ISPSC

2015 GROUP A PUBLIC COMMENT AGENDA

SEPTEMBER 30 – OCTOBER 5, 2015  
LONG BEACH CONVENTION CENTER  
LONG BEACH, CA

FIGURE [Add # Here]  
 FIGURE FOR TABLE 402.12(6)

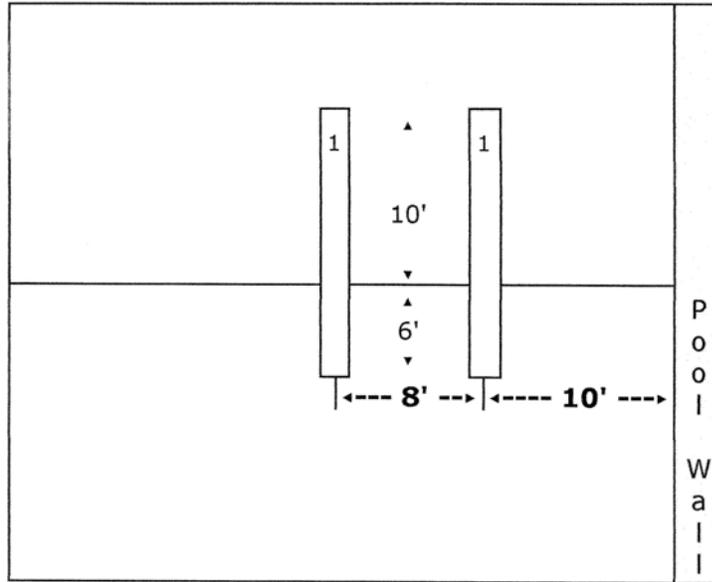
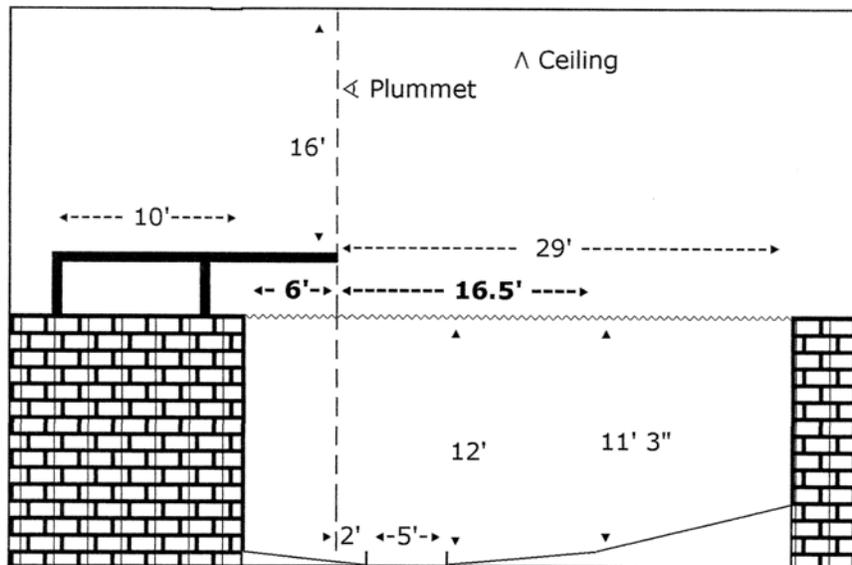
**Reason:** Architects, contractors, and zoning officers have often asked for a conversion table of the FINA dimensions to U. S. dimensions. The three national governing bodies have different diemnsional conversion standards. This information needs to be in this publication so that there is not misinterpretation of what is required in USA Diving, NCAA, and high school diving facilities to guard against a facility not being able to a sanction for competition.

**FIGURE [Add # Here]  
**FIGURE FOR TABLE 402.12(6)****

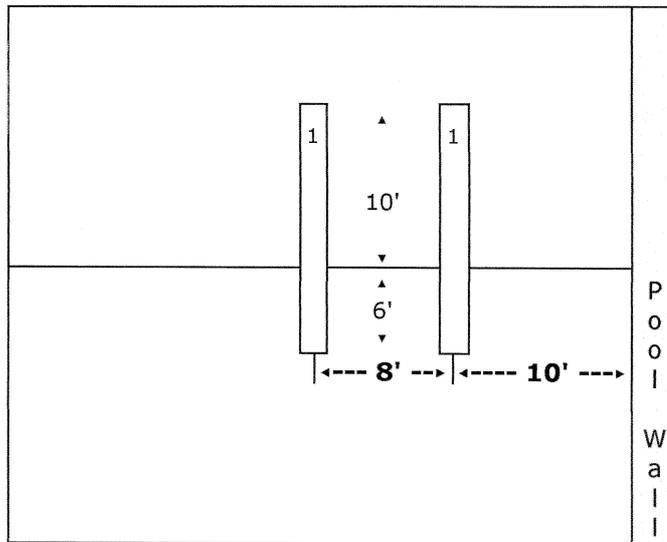
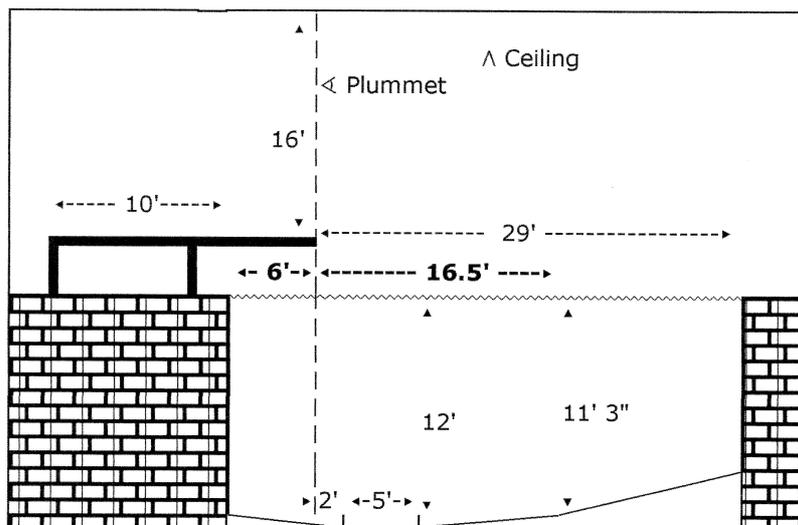
**Reason:** Architects, contractors, and zoning officers have often asked for a conversion table of the FINA dimensions to U. S. dimensions. The three national governing bodies have different diemnsional conversion standards. This information needs to be in this publication so that there is not misinterpretation of what is required in USA Diving, NCAA, and high school diving facilities to guard against a facility not being able to a sanction for competition.
